Well Name: CODORNIZ 28 FEDERAL

Sundry ID: 2712796

Type of Submission: Notice of Intent

Type of Action: Plug and Abandonment

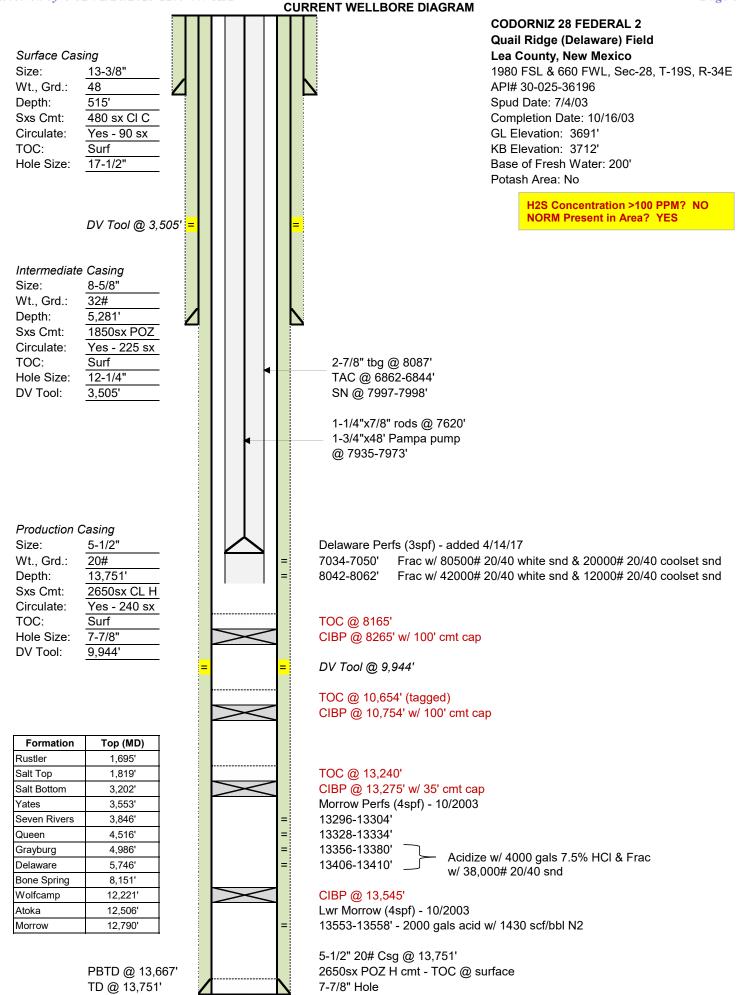
- 16. Attempt to break circulation, verify lifting pressures.
- 17. Delaware Plug: 5796' to 5638'. 25sx Min
- 18. Spot 25 sx Class C Cement from 6,934' 6,674' (Perfs).

- 19. WOC
- 20. Tag TOC and pressure test casing to 1,500 psi for 15 minutes.
 - a. Do not exceed burst pressure of casing.
 - b. Plug must be at least 100' (6,834').

- 22. Perf 50' below the int. shoe at 5,331' and attempt to establish injection.
 - a. Squeeze or spot min. 25 sx Class C Cement from 5,331' 5,071' (Int csg shoe).

- b. WOC & tag plug.
 - c. Minimum plug depth of 5,231' (50' above int. csg shoe).
- 23. Spot 50 sx Class C f/ 3,603' 3,102' (DV Tool/Salt Bottom, Yates). WOC and Tag
